**BCC DS**  
**RECEIVED**  
08-MAY-2026  
**APPLICATION REF**  
A007020190

DA Set - 21.02.2024.

DA Set - 15.02.2026.

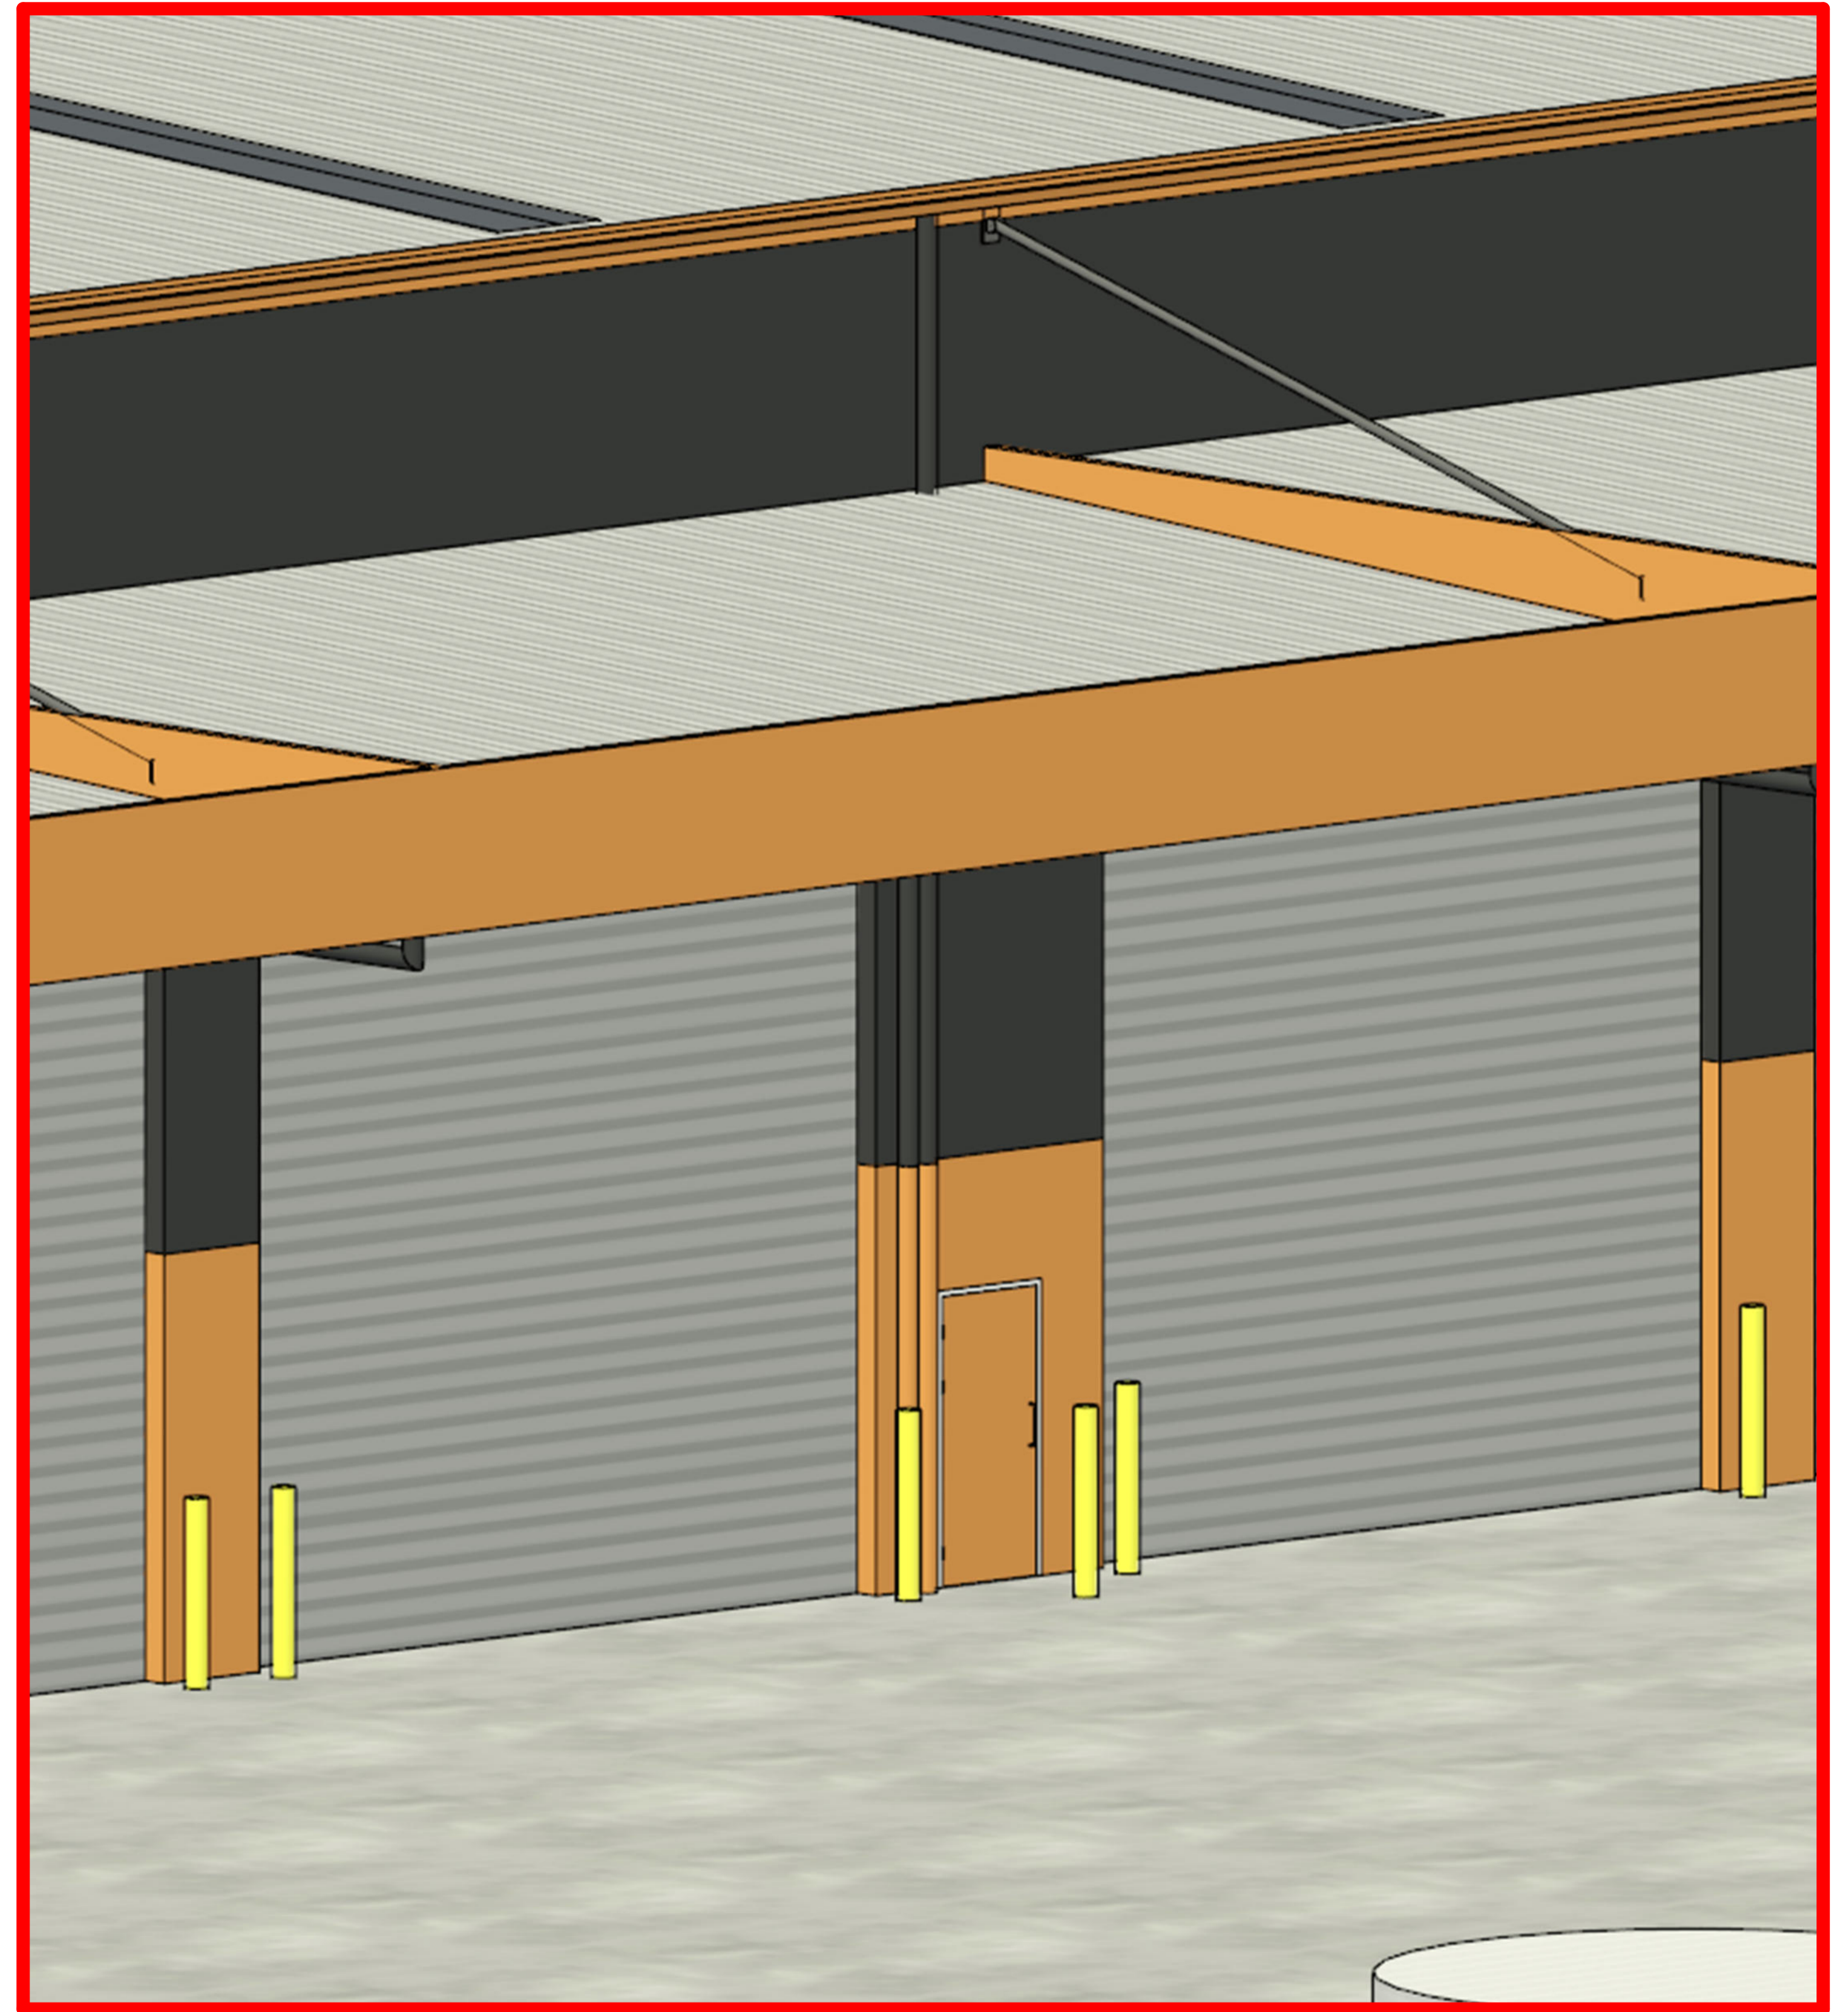
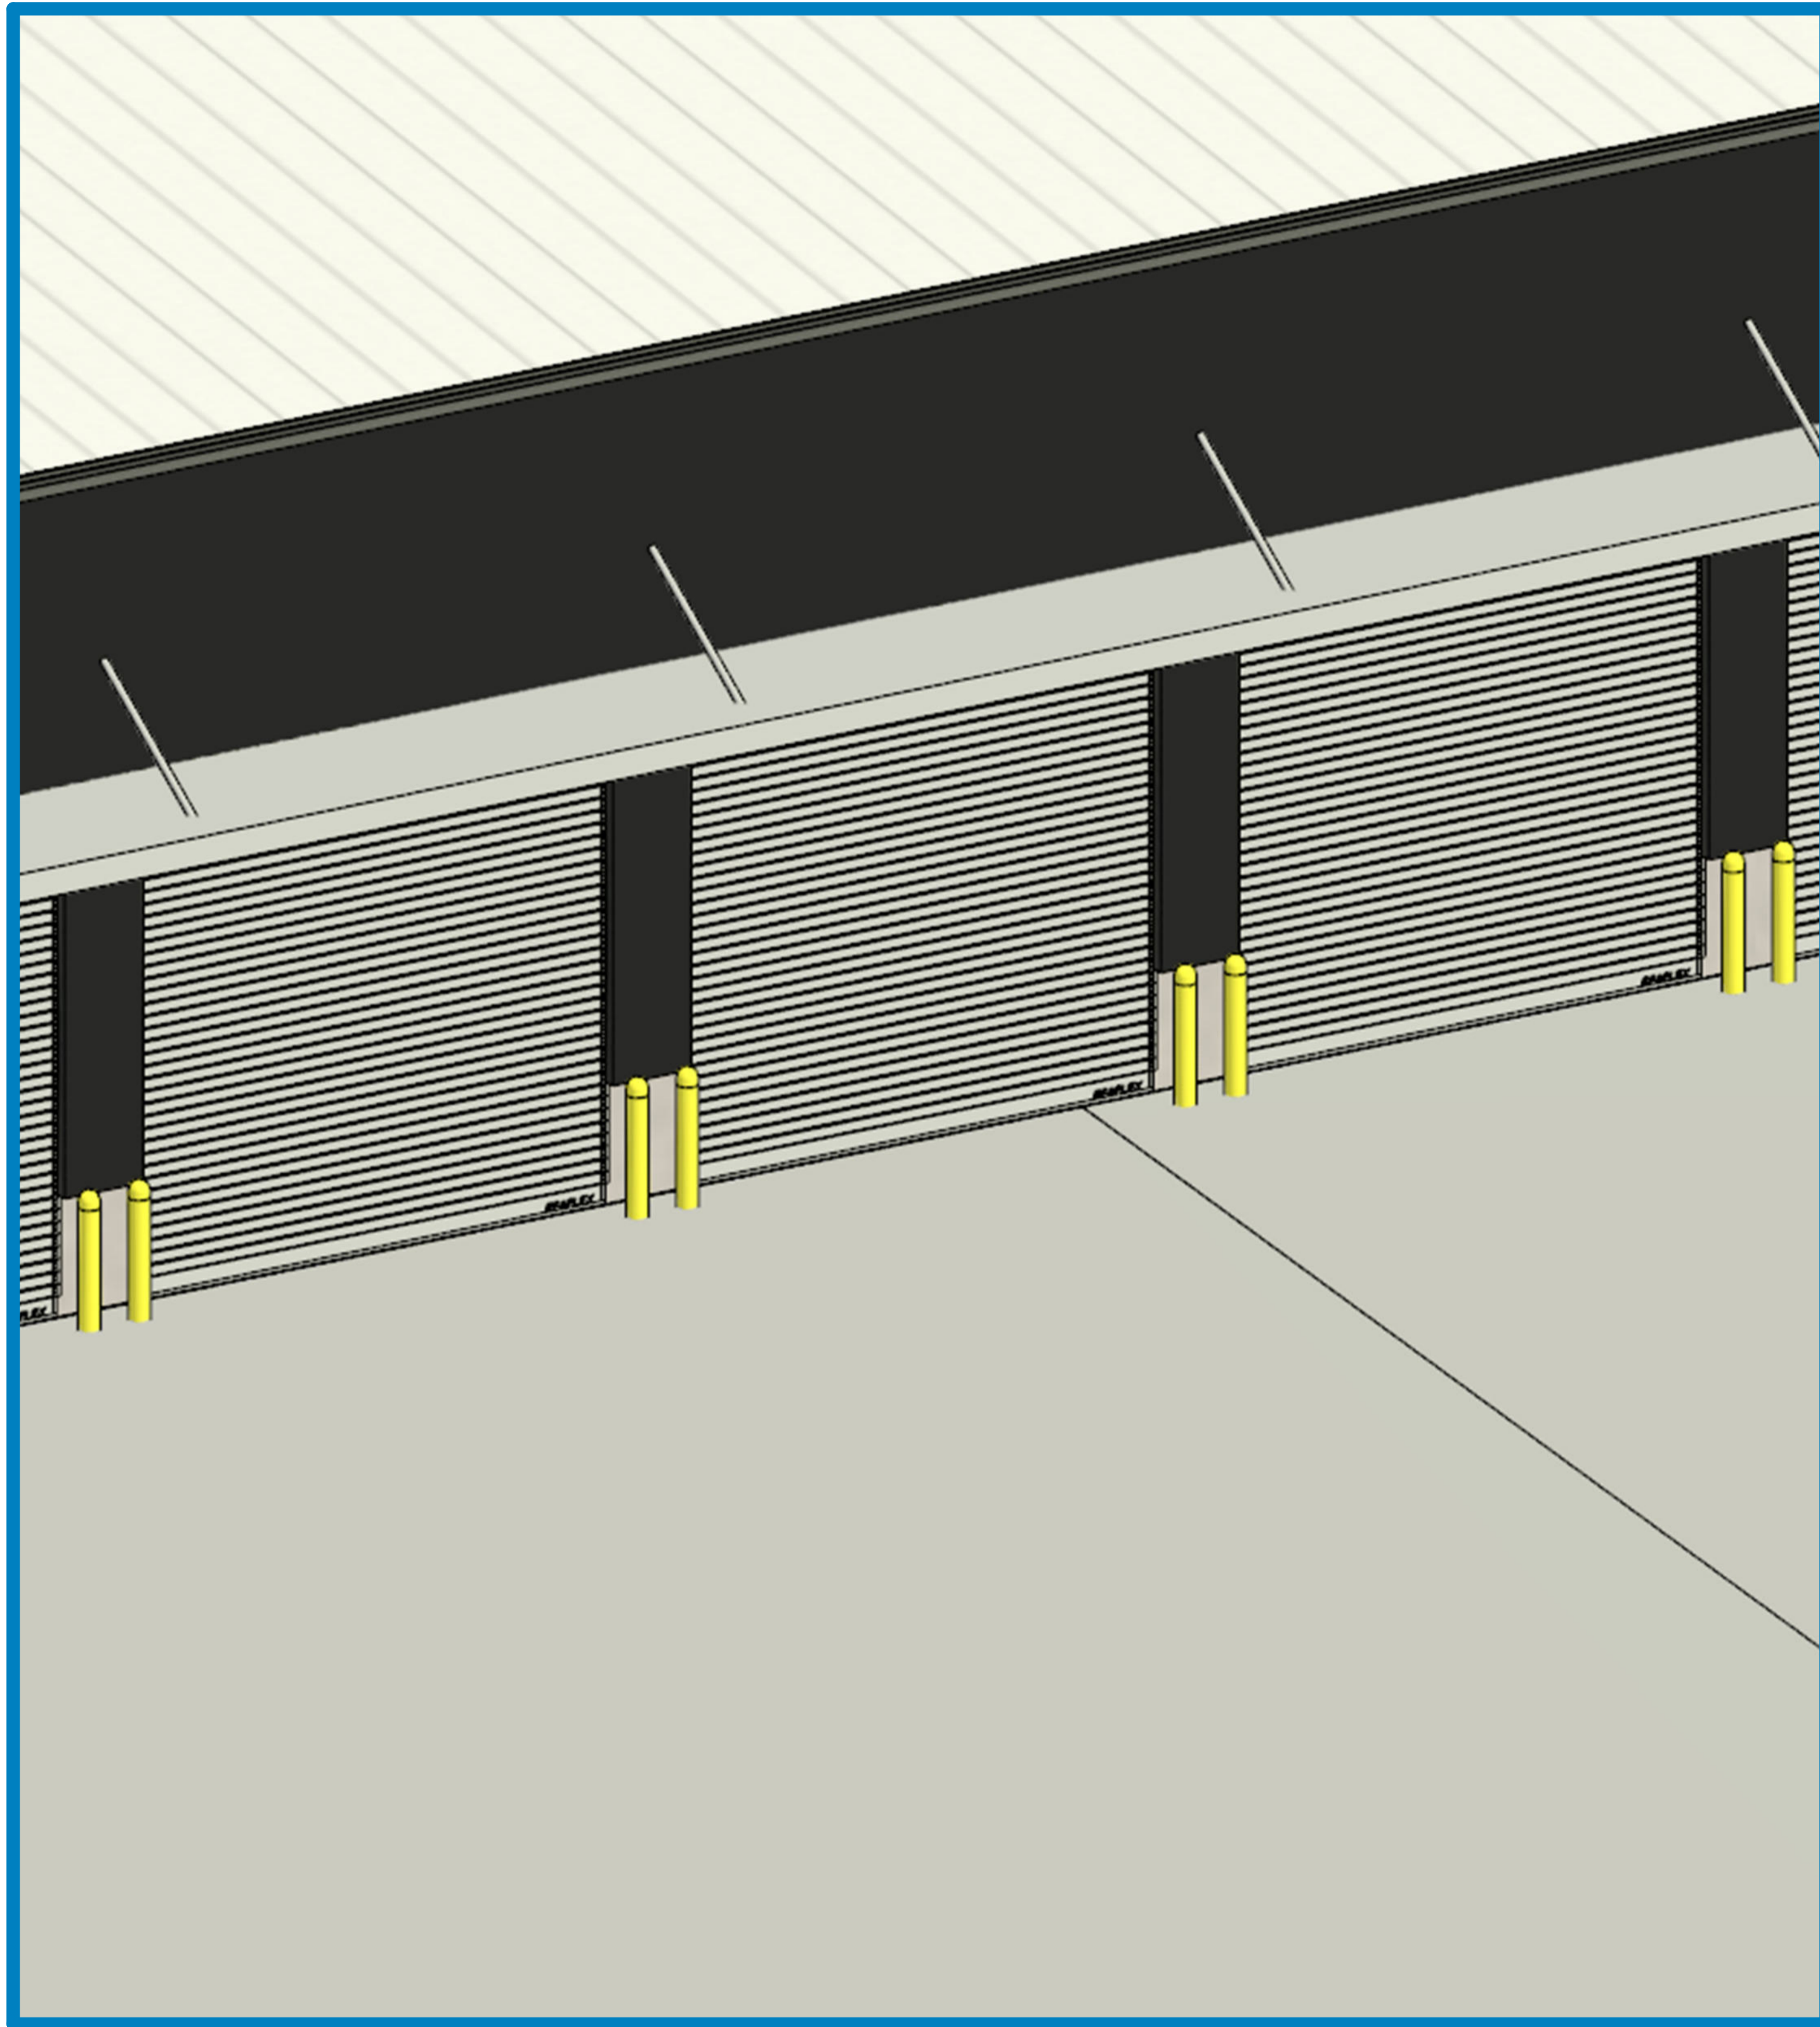
13. An emergency egress door has been added adjacent to the warehouse roller doors.
